# Clarification #4

PROJECT: SQUAMISH-LILLOOET REGIONAL  
DISTRICT MUNICIPAL OFFICE  
1350 ASTER ST.,  
PEMBERTON, BC

## Title: Clarification of Bidding Documents issued for Bid Package

# Clarification #5

IMAGE 1

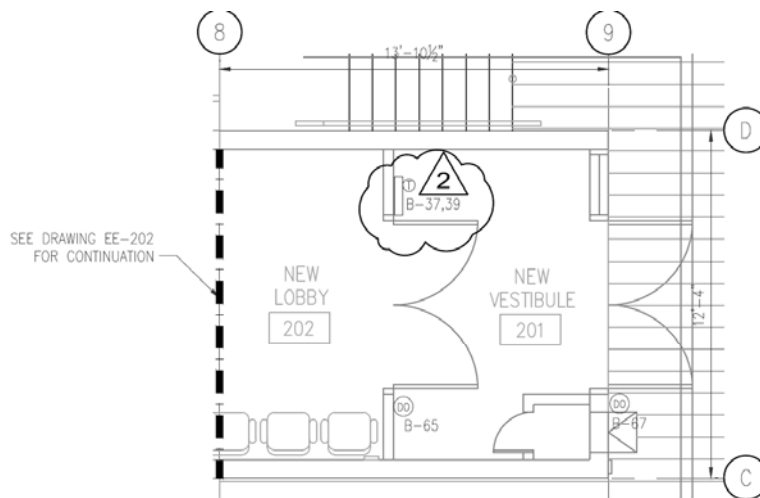
1. Please note that the new FCU-1 at New Vestibule room 201 to be deleted. (please see IMAGE 1 below)
2. Also, the new baseboard heater to be added at New Vestibule room 201 (please see IMAGE 2 & IMAGE 3 below)
3. Addendum to follow.

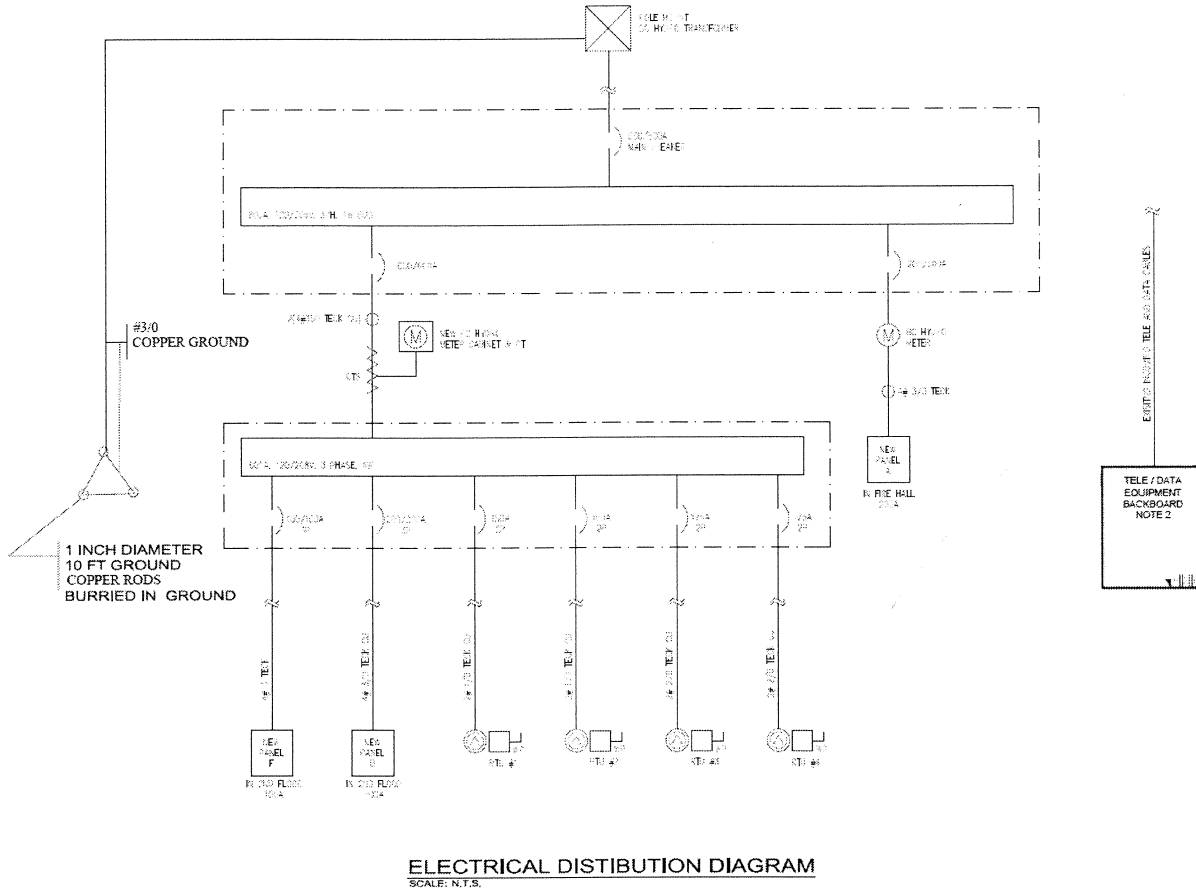
6. Are existing lights already on Timeclock or are we required to modify/update?
7. Please provide grounding detail for new electrical service.
8. Is there confirmed design and installation date for the BC Hydro service upgrade?

7. See image below. (responded by NU WESTECH )
